**ADDENDUM NO. 1**  
**2025 ROAD MAINTENANCE**  
**CITY OF DICKINSON, ND**

NO.	1	DATE	3/31/2025	REVISION	ADDENDUM #1 - ADD BID ITEMS FOR UTILITY SERVICES
DRAFTED JSK					
REVIEWED AK					
PROJECT NUMBER 2404-00273					
ISSUE DATE 3/18/2025					
2025 ROAD MAINTENANCE CITY OF DICKINSON DICKINSON, NORTH DAKOTA PLAN NOTES					
SHEET 6-1

8-1

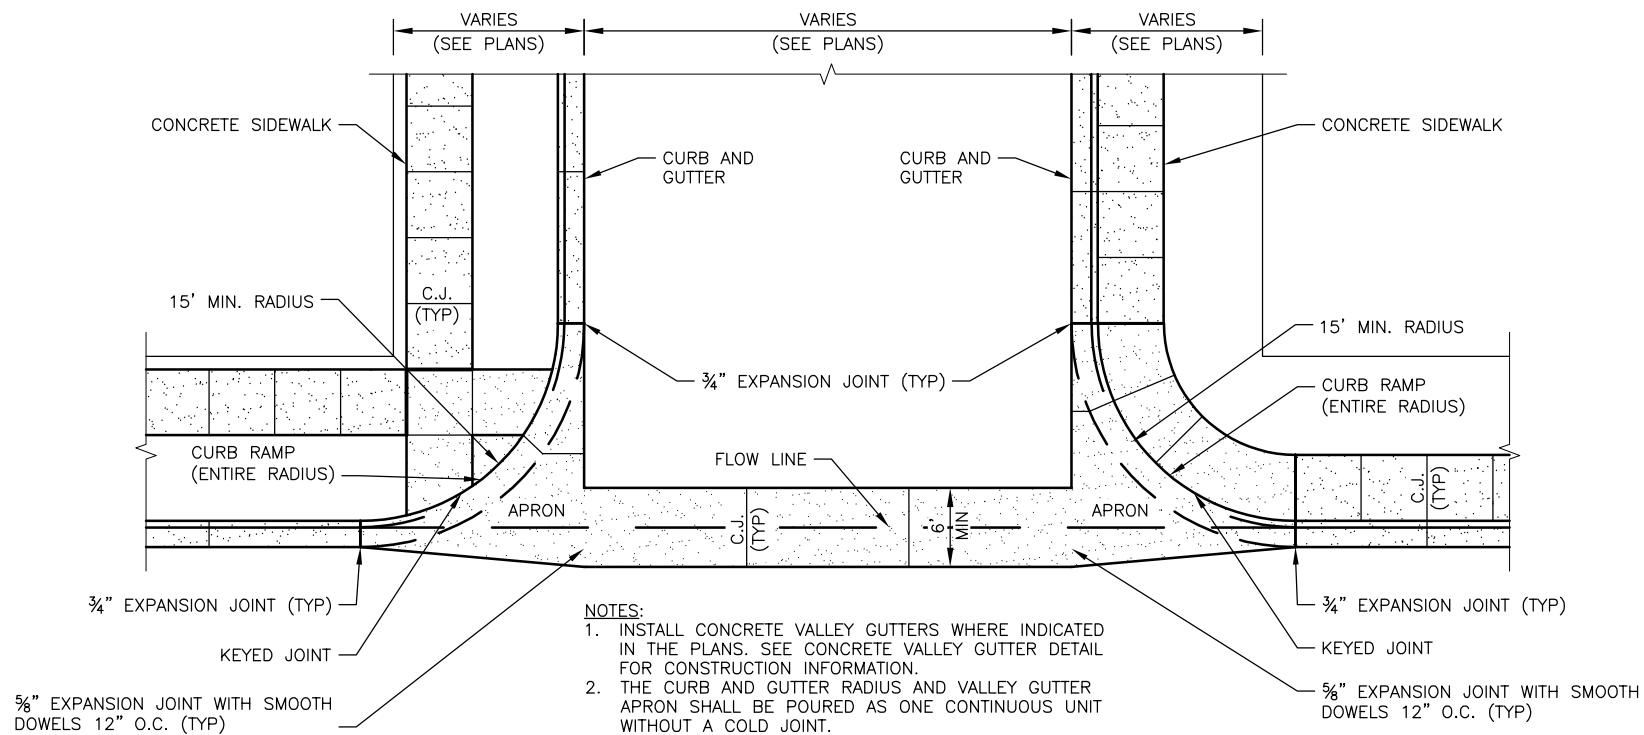
1. Section 6: Added Bid Items to replace any service lines or watermains that may conflict with new 54" Storm Sewer line. Attached is an updated Bid Form (Section 00300) with the new items included.
2. Sheet 8-1: Updated to reflect updated quantities and new bid items.
3. Section 20: Fixed note numbering and references on Sheet 20-3 and added Sheet 20-14.
4. Sheet 50-1 to 50-3: Adjusted grades on Arch pipe and added pipe quantities for watermain crossing.

### WATERMAIN & WATER SERVICE GRADE CHANGE AT CROSSINGS

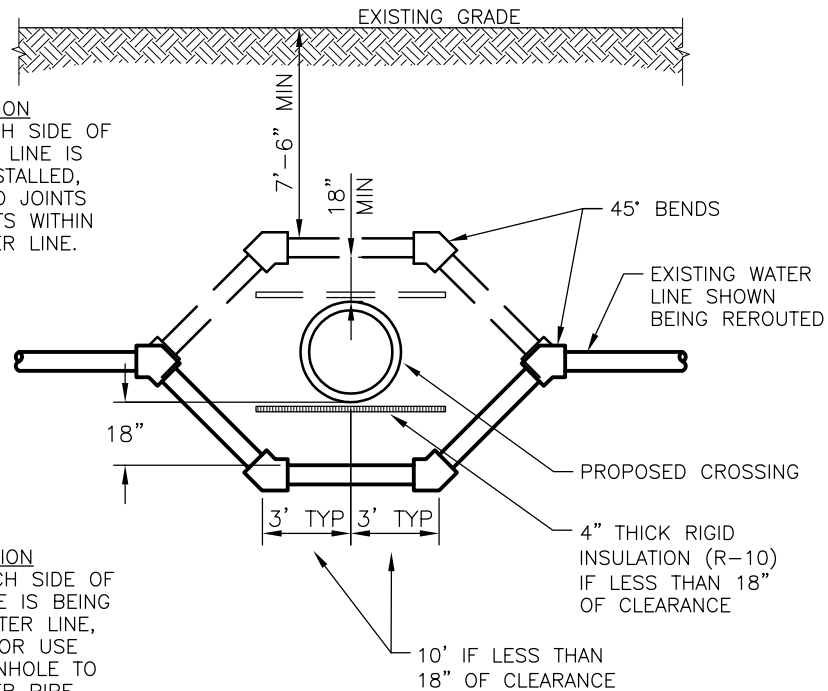
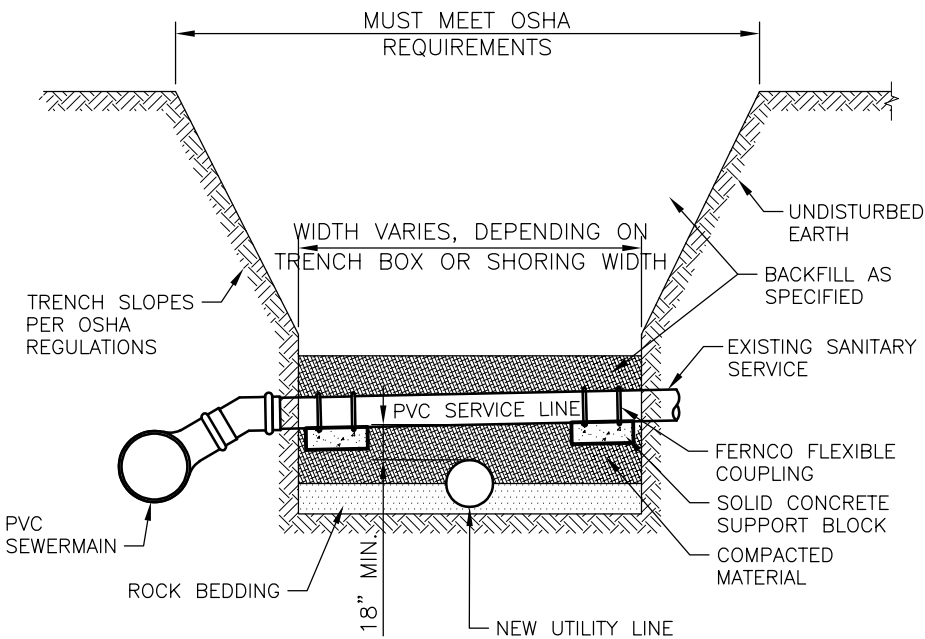
NO.	DATE	REVISION
1	3/31/2025	ADDENDUM #1 - ADDED DETAILS FOR CROSSINGS AND PLUG

- "WATER" INCLUDES WATERMAINS AND SERVICE LATERALS.
- "SEWER" INCLUDES SANITARY SEWER, STORM SEWER AND RECLAIMED WATERMAINS AND LATERALS.
- PROVIDE 18 INCHES MINIMUM OF VERTICAL SEPARATION BETWEEN WATER AND SEWER LINES. WHEN SEPARATION CANNOT BE OBTAINED AND IN CASES WHERE WATER LINES MUST BE ROUTED UNDER EXISTING SEWER LINES, LOWER WATER LINE AS SHOWN ON THIS DETAIL.

- 22.5' BENDS MAY BE USED IN LIEU OF 45' BENDS.
- PAYMENT FOR GRADE CHANGE CROSSINGS, INCLUDING FITTINGS, WILL BE INCLUDED IN THE BID PRICE FOR PVC WATERMAIN.

- WHERE 18" CLEARANCE CANNOT BE ACHIEVED, CONTRACTOR TO USE FLOWABLE FILL IN PLACE OF BACKFILL IN ACCORDANCE WITH CITY SPEC 31 2316.13 3.5E. THE PRICE OF THIS WORK SHALL BE INCLUDED WITHIN THE COST OF THE STORM SEWER PIPE ON THE BID FORM.
